#### Preliminary Plan No. 120140180, Potomac Chase – 12710 High Meadow Road

#### Preliminary Plan No. 120140180, Potomac Chase

Request to create six (6) lots from 1 unplatted parcel and one (1) platted outlot; located at 12710 High Meadow Road; 7.44 acres; R-200, RE-2, and RE-2C zone; Potomac Subregion Master Plan.

Staff recommendation: approval with conditions

Figure 5: Proposed Neighborhood for the Resubdivision of Outlot A for Proposed Lot F

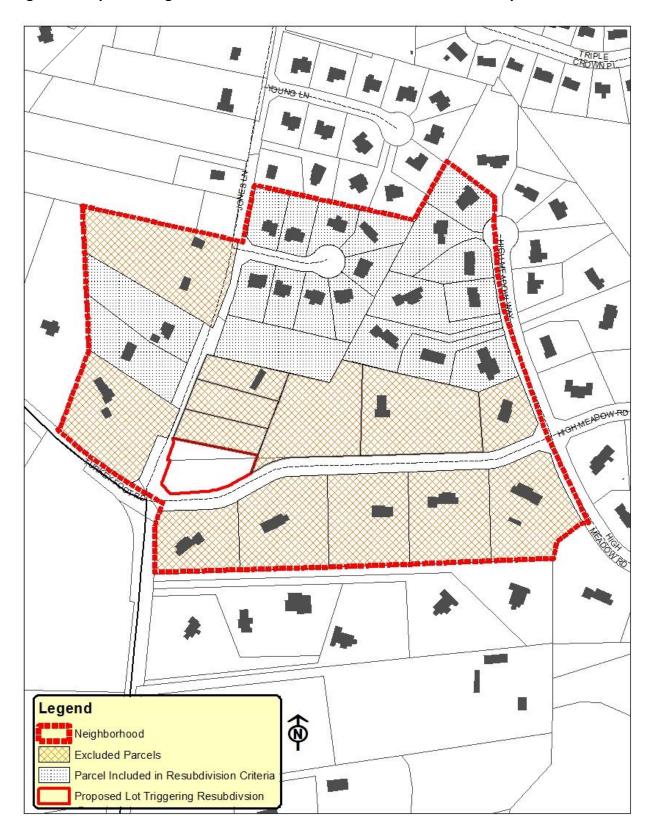
In administering Section 50-29(b)(2) of the Subdivision Regulations, the Planning Board must determine the appropriate resubdivision neighborhood ("Neighborhood") for evaluating the Application (Attachment 13). In this instance, the Neighborhood selected by the Applicant, and agreed to by Staff, consists of 20 lots (Figure 5). The analyzed lots include only properties that are recorded by plat in the R-200 Zone; are adjacent to the Subject Property, or were within a reasonable distance up and down Jones Lane to provide an adequate sampling of comparable lots. There are lots that are in close proximity to the resubdivided outlot but not included in the Neighborhood because they are zoned RE-2 or RE-2C. A map and tabular summary of the lot analysis based on the resubdivision criteria is included in Figure 5, Figure 6, Attachment 13, and Attachment 14.

The resubdivision analysis is a comparison of proposed Lot F and the lots in the resubdivision neighborhood because Lot F includes Outlot A (Figure 6) which comprises 0.67 acres of Lot F's 0.92 total acres.

Figure 6: Composition of Proposed Lot F

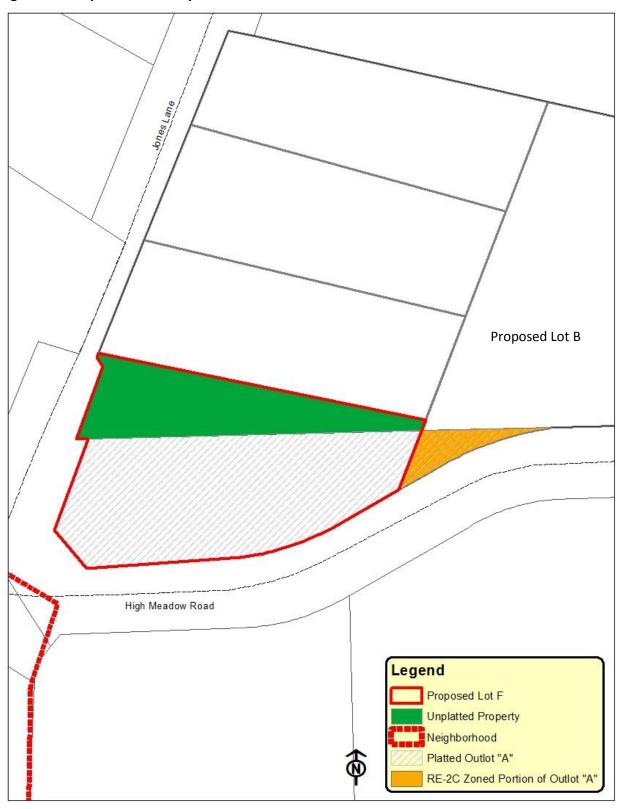
Pursuant to Section 50-38, the Applicant has submitted a request to waive resubdivision analysis for proposed Lot B (Attachment 16) as shown on the Preliminary Plan. This Application results in a 0.052 (2,265 square feet) acres remainder of Outlot A (Figure 6) which aligns perfectly with a fragment of RE-2C zoning. There are three alternatives to address this fragment: 1) Create a 0.052 acre outlot which provides no benefit. 2) Include this 0.052 acre fragment with Lot F which would create an irregularly shaped lot. 3) Include the 0.052 acre fragment with Lot B to create a lot with a logical lot pattern but by including this fragment of Outlot A, it triggers the resubdivision analysis. This Application includes this 0.052 acre fragment, only 2.2% of Lot B, triggering resubdivision analysis (Figure 6).

The minimum necessary is for the Planning Board to waive resubdivision analysis on Lot B which is triggered by the included fragment of existing Outlot A.
